**Regular Meeting Amended
Agenda of the Historic Districts
Review Board
May 26, 2026 at 5:00 PM
Community Room, Main Library
145 Washington Avenue
Santa Fe, NM 87501**

**City of Santa Fe
Historic Districts Review Board
Findings of Fact and Conclusions of Law**

DATE: May 26, 2026
TO: Historic Districts Review Board Members
FROM: Heather Lamboy, Planning & Land Use Department Director #LL

Figure 2. Excerpt from North Elevation (2/A203h)
 Scope of proposed addition shown relative to previously disturbed (noncontributing) façade. The proposed connection is primarily located at these locations; the exception concerns the 17" portion shown in red (38" at roof overhang).

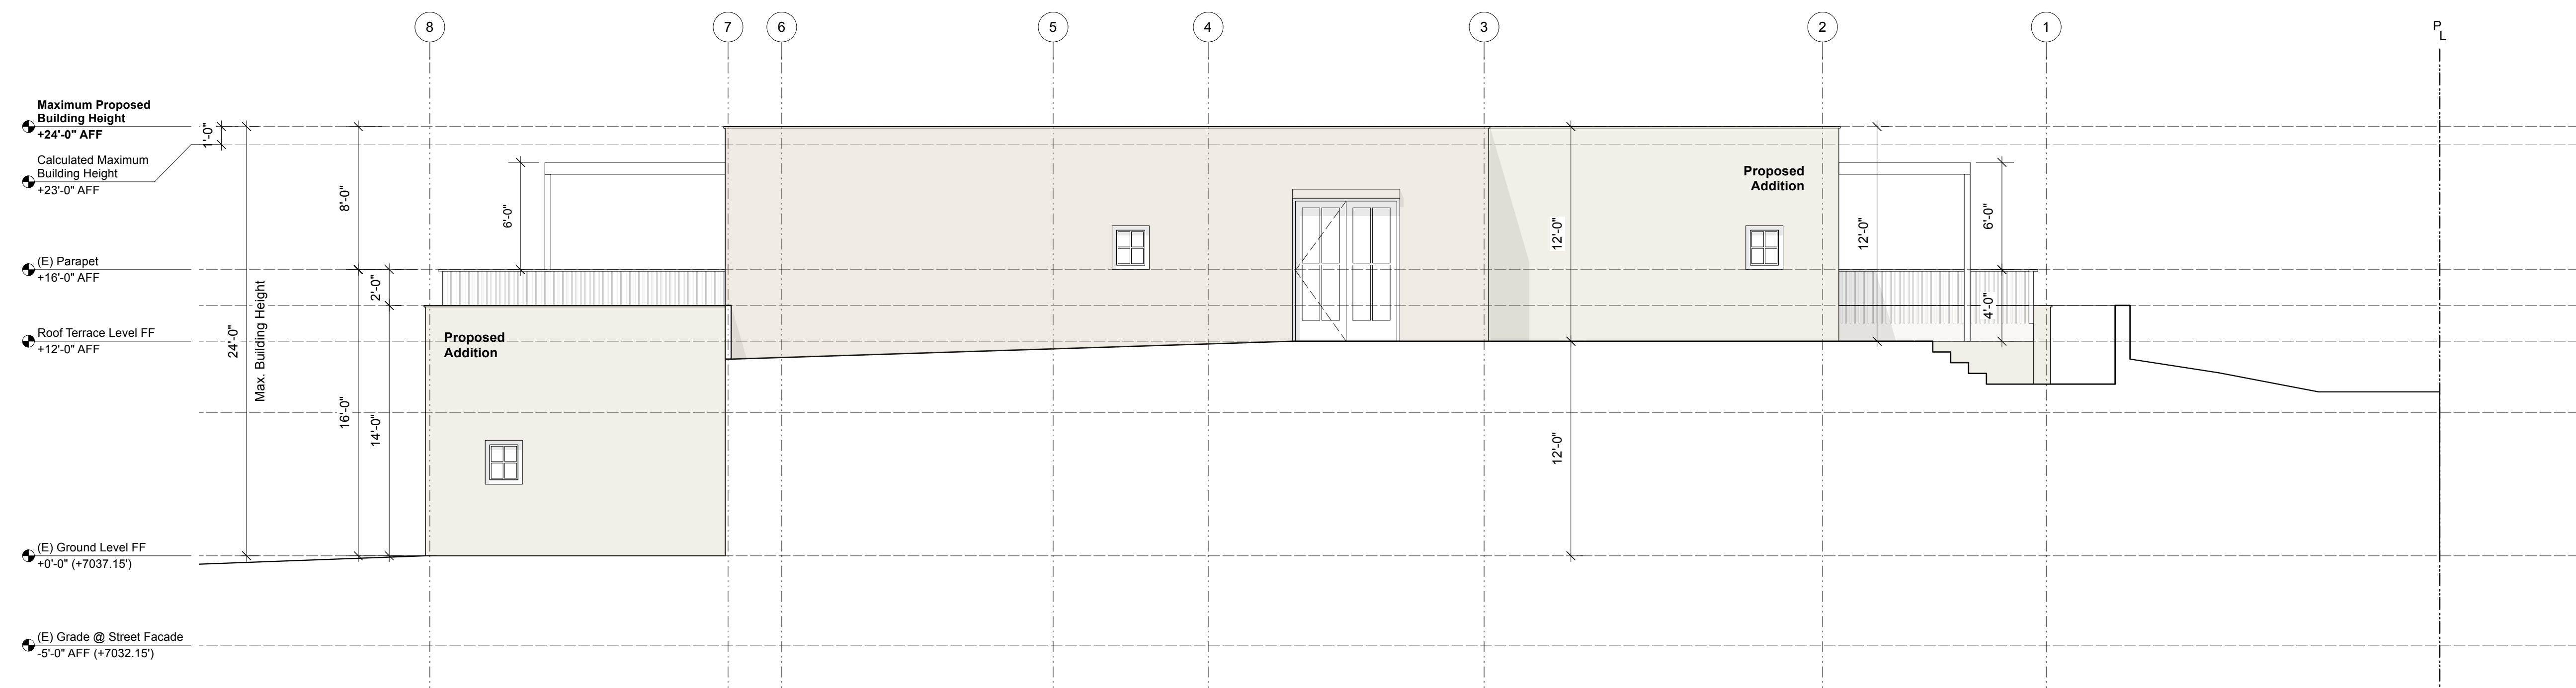
- (i) Do not damage the character of the district
- *Response:* The proposed addition the North facade of the historic house will not damage the character of the district, as its massing will be separated from the historic house and the connections to the original structure will be primarily limited to portions of the facade already altered by previous noncontributing additions. The Board approved these additions for demolition in October 2025, and their removal will leave exposed interior walls that will need to be replaced. The proposed design lightly touches the original house at two locations on the east and west ends of the façade, and this exception only concerns a 17” wide portion of the North façade (3’-2” wide at roof overhang) where the new structure touches the historic house outside previously disturbed areas (see Figure 2).

- The primary mass of the proposed addition will be set back 12 feet from the historic house, preserving the legibility of old from new. At the East end of the facade, an interior space about 18 feet wide will provide the primary “bridge” between the original house and the addition, and it will attach at portion of the north façade left exposed after demolition of a noncontributing addition. The interior space is recessed beneath a roof overhang on both sides. Its roofline is set back 2’-6” from the corner of the original North façade, and its interior mass is set back 7’-7” from the corner to further differentiate the addition and preserve the legibility of the original massing and historic brick parapet at the Northeast corner. This shift pushes the addition Westward and slightly outside the previously disturbed façade area, creating the overlay described in this exception. This alignment also allows the new construction to continue the line of one of the primary original structural brick walls within the historic house and to extend the space of a historic hallway. The existing wall below the roof overhang will be preserved, and no existing historic doors or windows will be compromised or altered in any way. Newly exposed exterior wall will be finished to match the adjacent historic stucco.

Figure 6: Façade Diagram

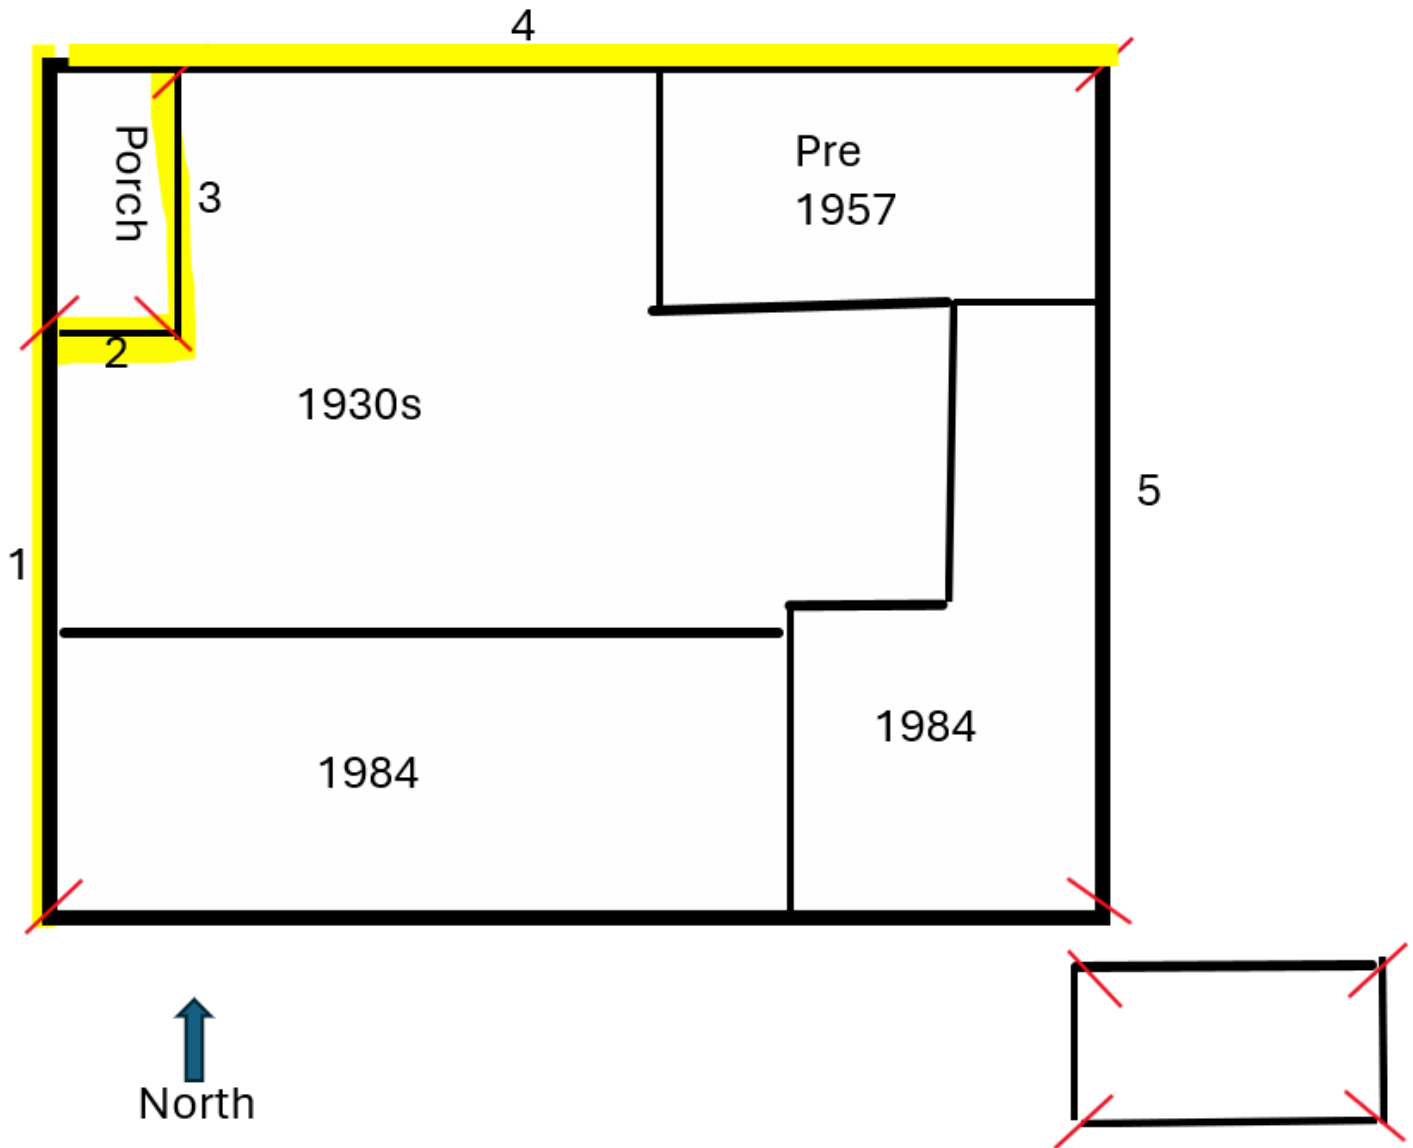
Staff finds the structure to be contributing to the district because of the original adobe construction material, the historic growth of the building, including the rear portal and small addition from the 1950s, and the solarium addition in 1978, which retains the overall appearance of the residence, the deep inset windows and doors, and the unique portal design.

Figure 5: Façade diagram

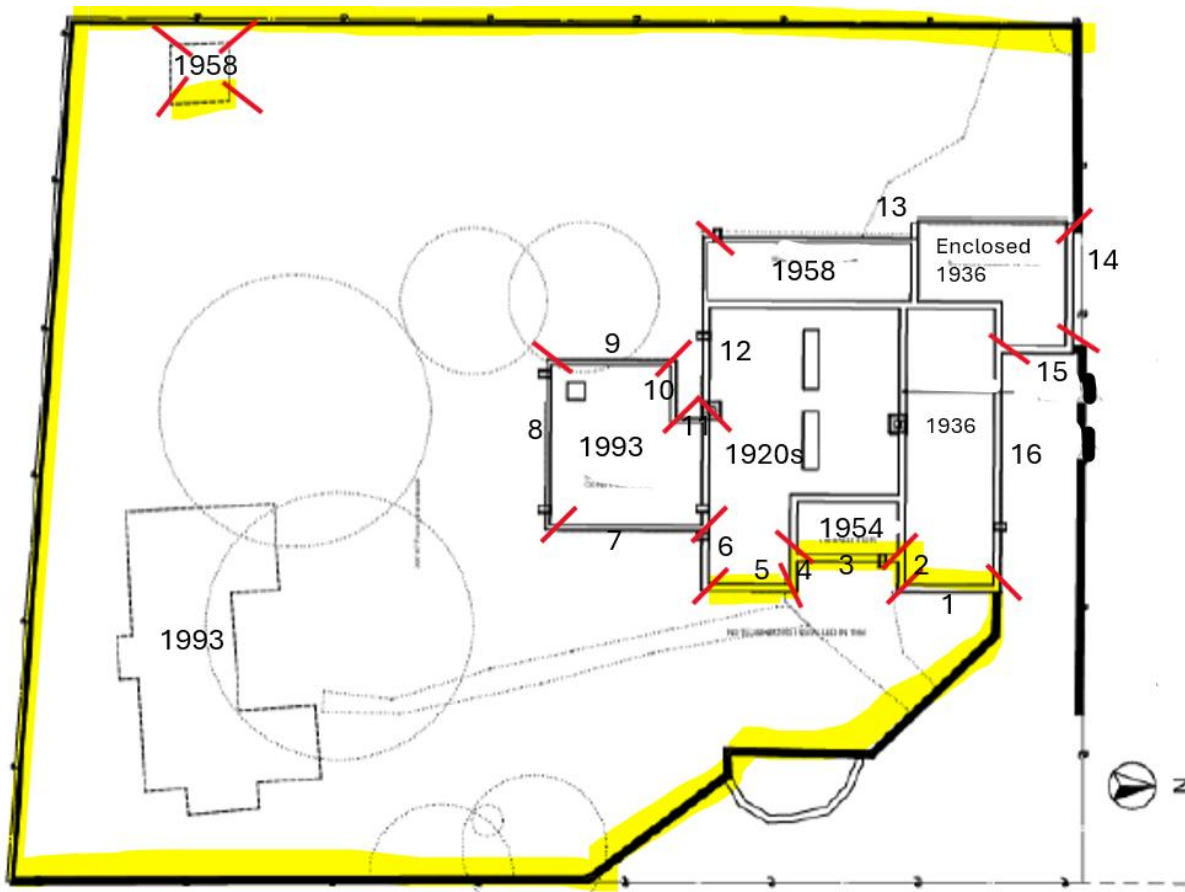
Staff finds that the status of the main residence has not lost any integrity and should remain as a contributing structure with the east as the primary façade. The guest house is non-contributing due to age. The shed does contribute to the district and is unique in its age, form, and materials. The east, west, and south perimeter walls also contribute to the street and the estate of the property.
